Re: Gas Transmission Network Output Measures Rebasing Consultation

This response is submitted by National Grid Gas plc. We operate and own the gas transmission assets in Great Britain and are referred to within the rebasing consultation as NGGT.

Re: Gas Act 1986, Section 23(2), Notice of statutory consultation on a proposal to modify Special Condition 7E of the gas transporter licence held by National Grid Gas plc.

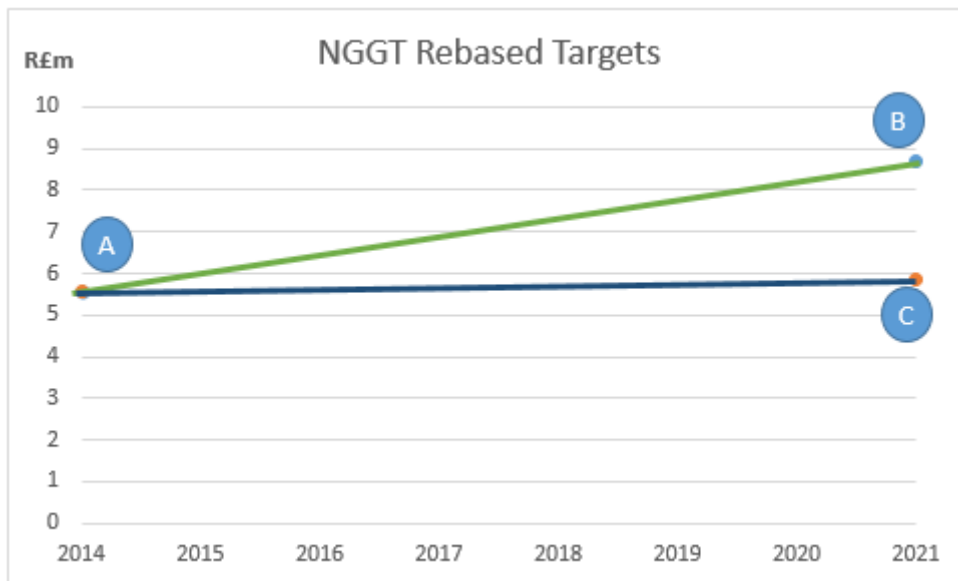
Figure 6 of the consultation is an illustration of the rebasing process for RIIO-T1. We do not think the graph correctly represent our target in comparison to the RIIO-T1 starting position. Our target set at the beginning of RIIO-T1 was to maintain risk at a broadly stable level. We therefore suggest replacing Figure 6 with the following graph using the monetised risk values provided as part of the rebasing process for RIIO-T1 starting position, RIIO-T1 end position with investment and RIIO-T1 end position without investments.

Step 1 – Starting Position of 2019 (Point A): Derive the monetised risk position at start of RIIO-GT1.
 Step 2 – End Position of 2021 without Interventions (Point B): Derive the monetised risk position without interventions at end of RIIO-GT1 by applying expected asset deterioration.
 Step 3 – End Position of 2021 with Interventions, this is the target our performance is measured against (Point C): Derive the monetised risk position with interventions at end of RIIO-GT1 by applying the impact of asset interventions required under RIIO-GT1 Final Proposals (RIIO-GT1 performance target).
